**LIFE SAFETY ASSESSMENT
WESTERN STATE HOSPITAL
LAKEWOOD, WASHINGTON 98498**

**Prepared For
WASHINGTON DEPARTMENT OF SOCIAL
AND HEALTH SERVICES (DSHS)
1115 Washington St. SE
Olympia, WA 98504**

June 01, 2018

Figure 2: Snip from First Floor Bldg 9 to Bldg 17

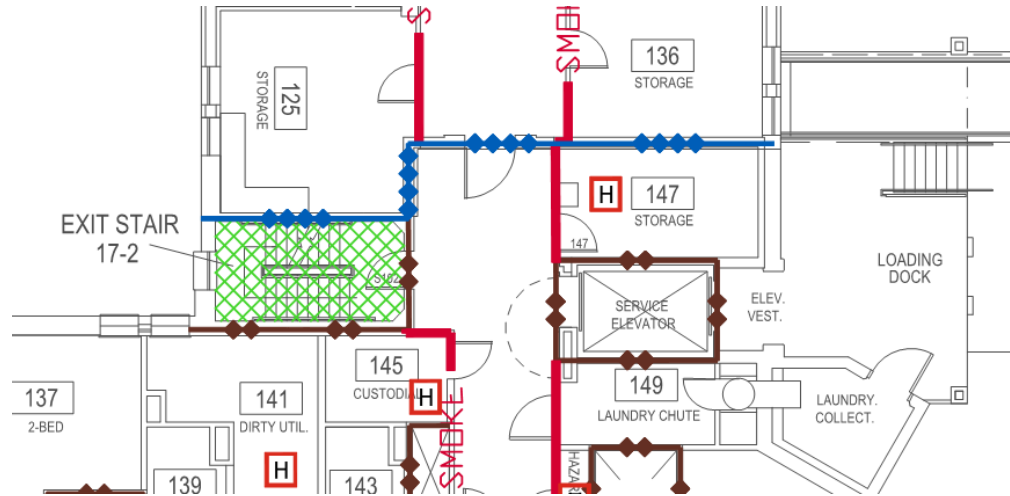
On the large inter-connected buildings: specifically, in between Buildings 28 and 29 and between Buildings 9, 17, 18, 19 and 20, a 4-hour fire barrier is listed on the existing life safety plans to separate each building. See Figure 2 below as an example (the navy-blue line type with 4 diamonds).

We suspect this is an attempt to meet the requirements of the 2015 IBC in terms of allowable area by introducing a catch-all wall type that separates buildings into smaller floor areas that meet the IBC allowable area tables. In the case of the example above (Building 9), there are 3-hour fire doors and a cast-in-place concrete wall at each floor that appears thick enough to meet a 4-hour rating. However, the walls have been cast in between floors and this wall does not provide the structural independence required of a true fire wall. In other cases (such as at Building 28 to 29) the doors in this location are only 20 minute-rated and the wall is a combination of cast in place and framed wall, not meeting a 4-hour separation.

When establishing type of construction for existing buildings, the better practice is to classify a building by what it can be based on applicable codes as opposed to what the building looks like based on observed construction. Due to the type of construction listed for most buildings as Type II, (see further in this report regarding Building 28) we recommend that these fire walls be re-designated to 2-hour fire/smoke barriers in order to meet the occupancy separation requirements of the LSC and better represent what these walls are actually accomplishing.

The justification is that the LSC does not limit the allowable area of buildings, only the allowable height, per Table 19.1.6.1. Since these building are all existing, they should not be required to meet the most current edition of IBC or its allowable area tables. However, in light of attempting to provide some form of separation, the IEBC (International Existing Building Code) Section 10.12.5.1.1 allows existing buildings to have fire walls constructed as fire barriers to meet the intent of building area separation. Since these buildings are being considered as Type II via the LSC, a 2-hour fire wall, or fire barrier in this case is allowed. We recommend the additional designation of smoke barrier to ensure that existing smoke compartment boundaries are not being violated.

The risk being run by continuing to call these walls 4-hour fire walls is that they will continue to incur comments, both in terms of the actual rating and the continuity requirements for fire walls which is not possible given existing construction.

Figure 3: Excerpt from NFPA 101 Handbook

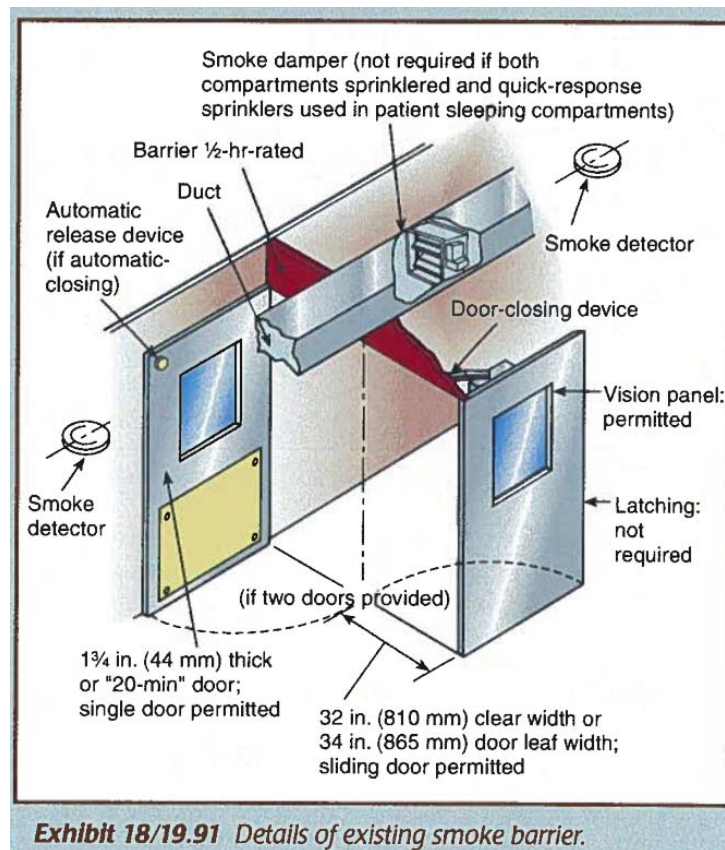
However, per LSC Section 19.3.7.3 (2) smoke dampers are not required when penetrating a smoke barrier provided:

- HVAC is fully ducted from source to register
- The building is sprinkler protected

The snip below in Figure 3 shows the intent of omitting dampers at smoke barrier walls. It should be noted that standard response sprinklers are permitted where quick response sprinklers were not listed for use in such locations at the time of installation (LSC Section 19.3.5.8).
